SITE PLAN

PERRY TOWNSHIP, LAKE COUNTY, OHIO

for: McCULLOUGH BUILDERS
CLIENT OWNER

DRAWN BY	SCALE 1" = 30'	PHONE NO. 357-1811
CHK'D.	DATE 11-20-92	DRAWING NO. 92-107-C
CREW CHIEF KJ	APP'D.

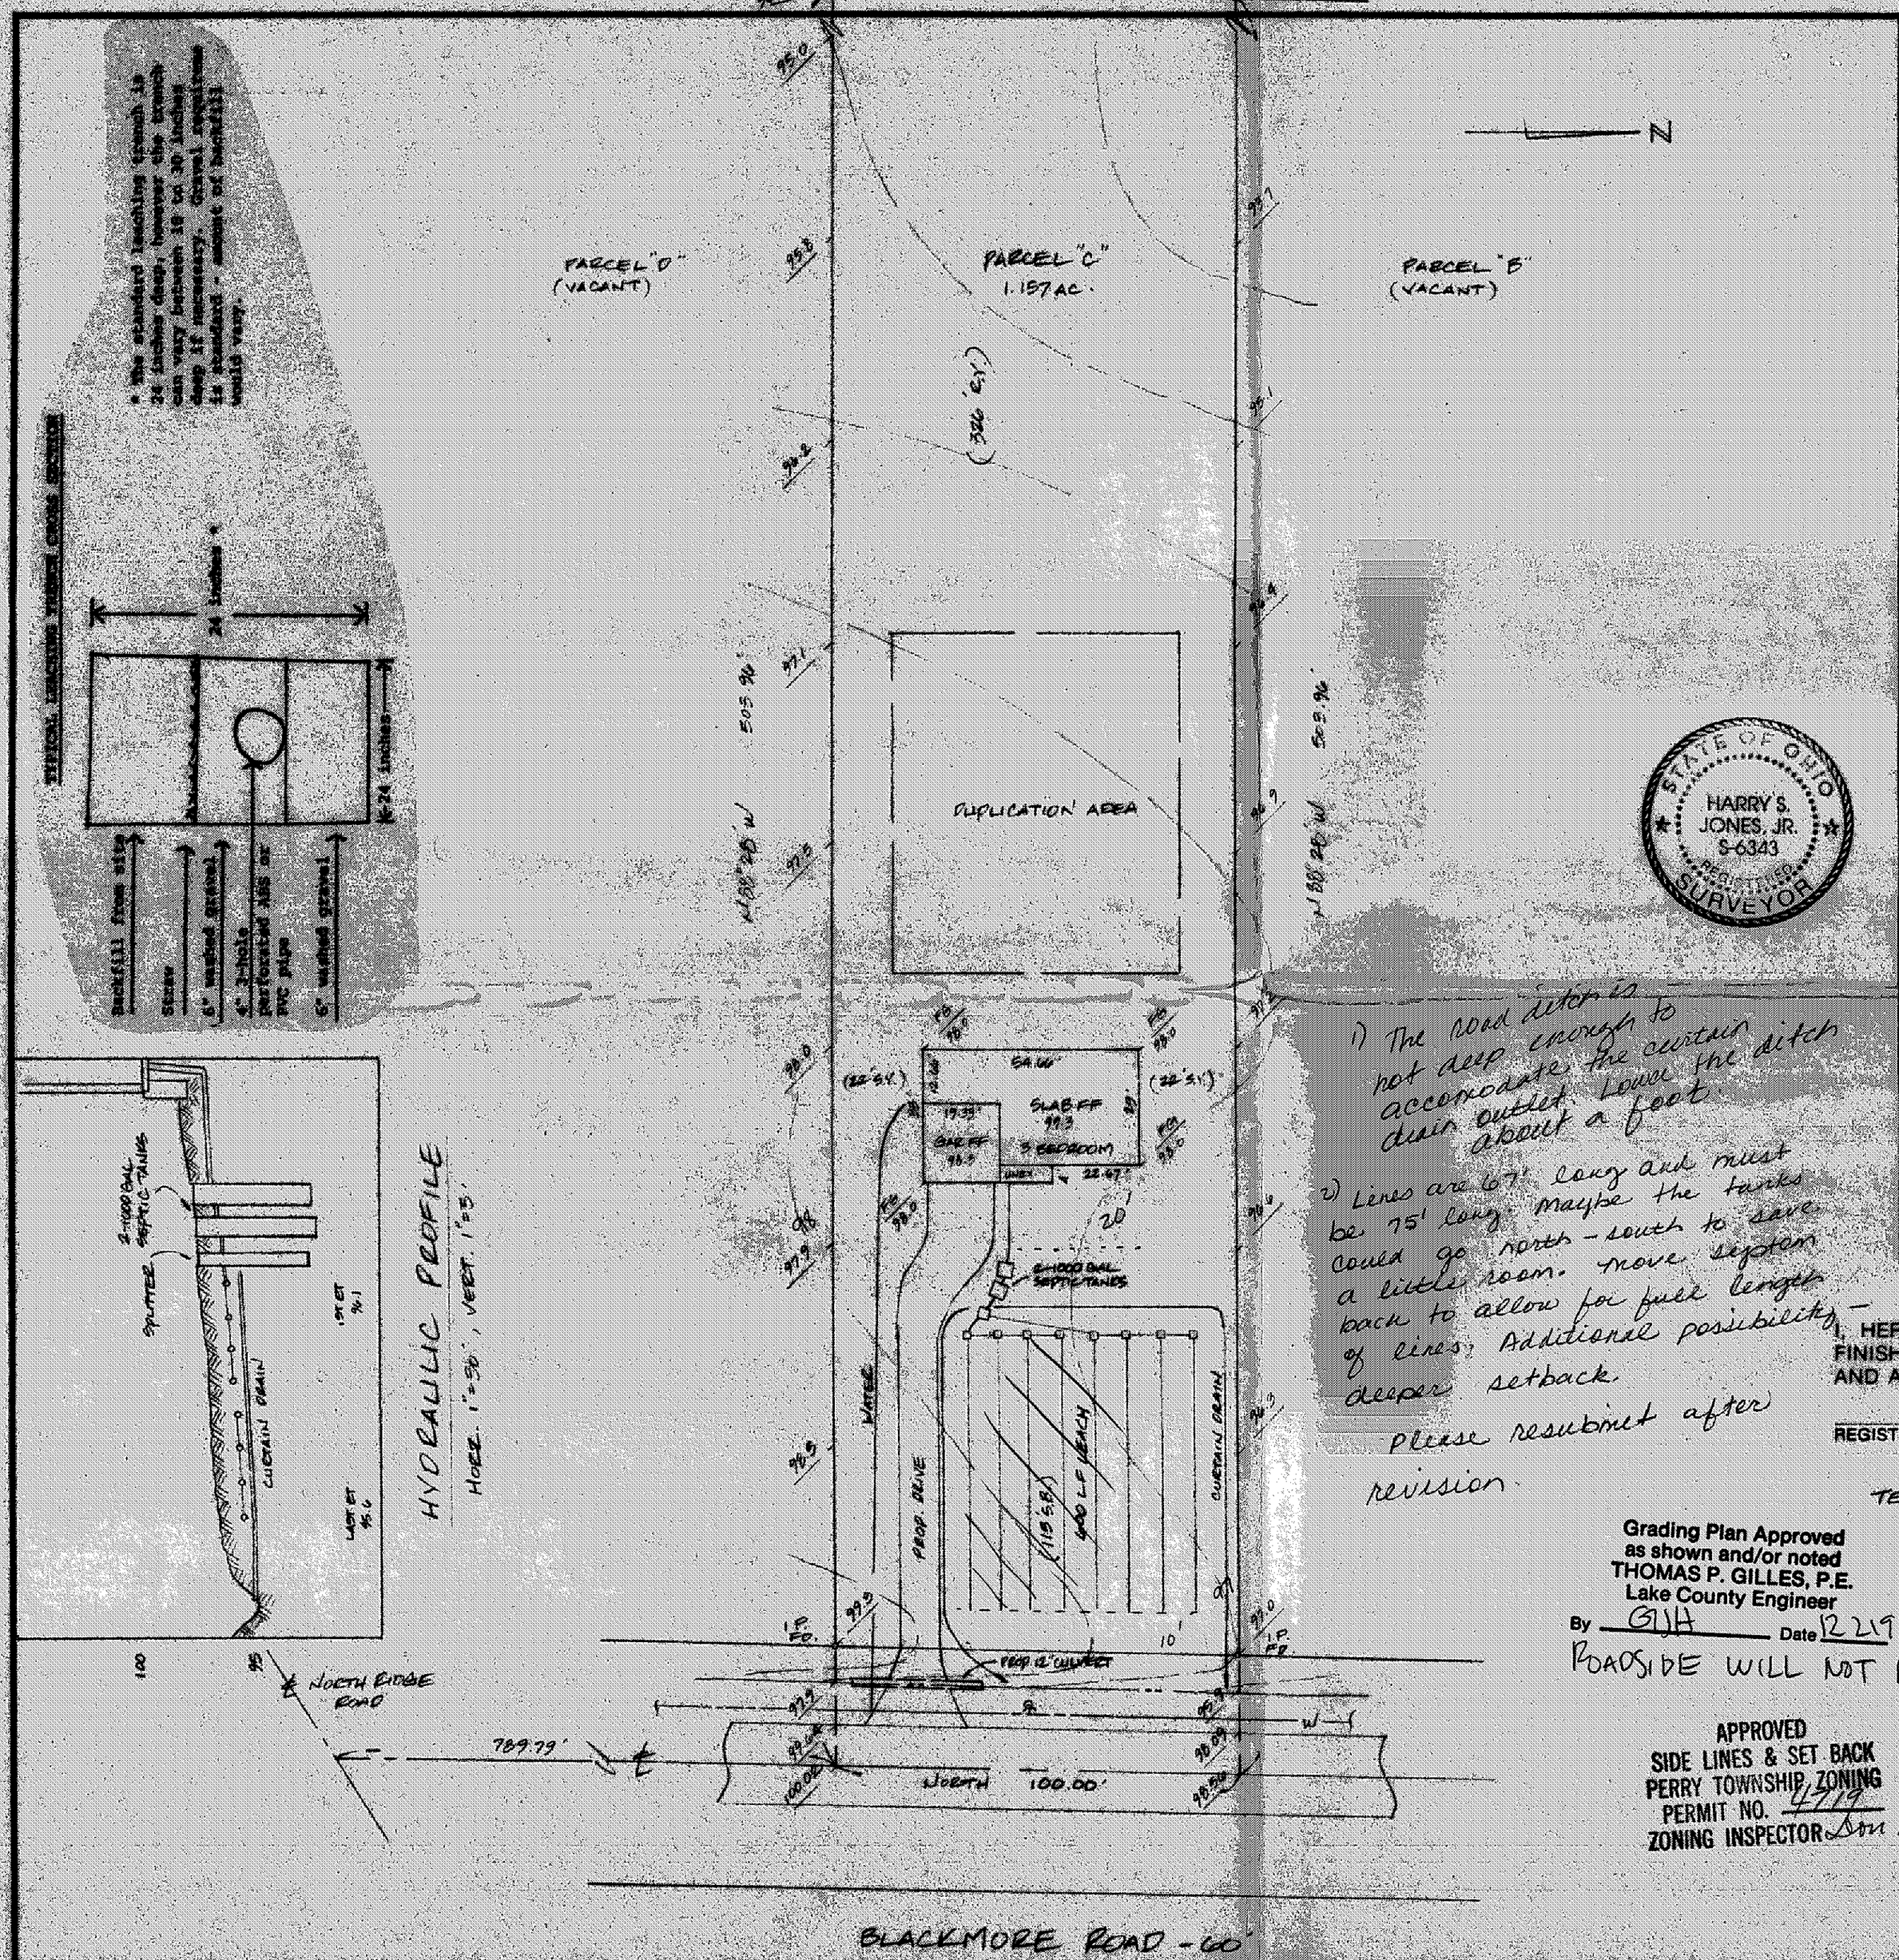
1) The road ditch is not deep enough to accomodate the curtain drain outlet. Lower the ditch about a foot.

2) Lines are 67' long and must be 75' long. Maybe the tanks could go north-south to save a little room. Move system back to allow for full length of lines. Additional possibility — deeper setback.

Please resubmit after revision.

ROADSIDE WILL NOT BE LOWERED!
